CBD and South East Light Rail EIS

Gateway Plaza Urban Design Response

Client: DEXUS
 Date: December 2013
 Revision: B
 Document: 13080 [CSLER EIS Urban Design Response]

2.1. Staging

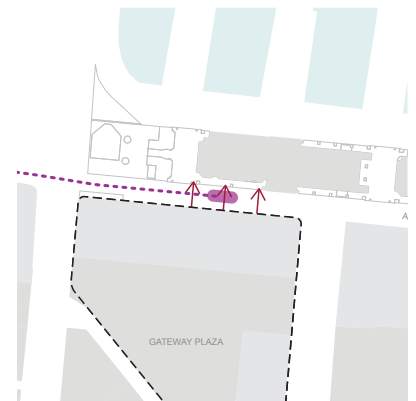
A staged construction approach of the Light Rail infrastructure, stop and delivery of new public domain is suggested to minimise disruption and potential loss of business, lessening the adverse affects of the Light Rail during its five-six year forecasted construction period.

The staged approach will enable revitalised public domain on Alfred Street, Pitt Street and Loftus Street to be released and experienced by everybody prior to the completion of the Light Rail infrastructure. A staged approach should also maintain connectivity between Circular Quay and the street network south of Alfred Street.

3.3. Termination of Pitt and Loftus Streets

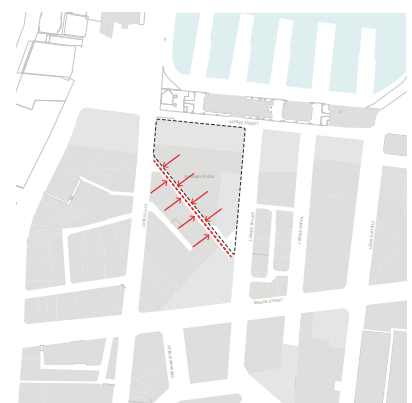
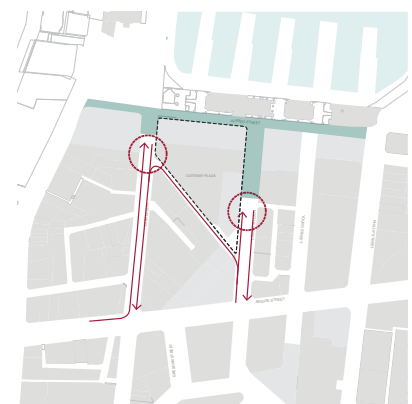
The location of the termination of Pitt Street and Loftus Street will be critical in determining the character of public domain throughout Circular Quay. Any terminus of Pitt and Loftus Streets should be configured to minimise or eliminate the encroachment of vehicular traffic on the pedestrian areas of Alfred Street.

We request that additional traffic investigation be undertaken with the adjacent stakeholders and property owners with a focus on creating a pedestrian only public domain from George Street to Loftus Street along Alfred.

The reconfiguration of vehicular movement along Pitt Street, Reiby Place and Loftus Street would allow for the termination of Pitt and Loftus Streets whilst maintaining a clear and logical vehicular movement. Timed vehicular access would maintain critical service and loading access to the buildings north of Bridge Street.

It is important that any terminus of Pitt and Loftus Street occur before the shoreline of the buildings along the southern edge of Alfred Street is reached, so that any encroachment into the pedestrianised zone of Alfred Street is eliminated.
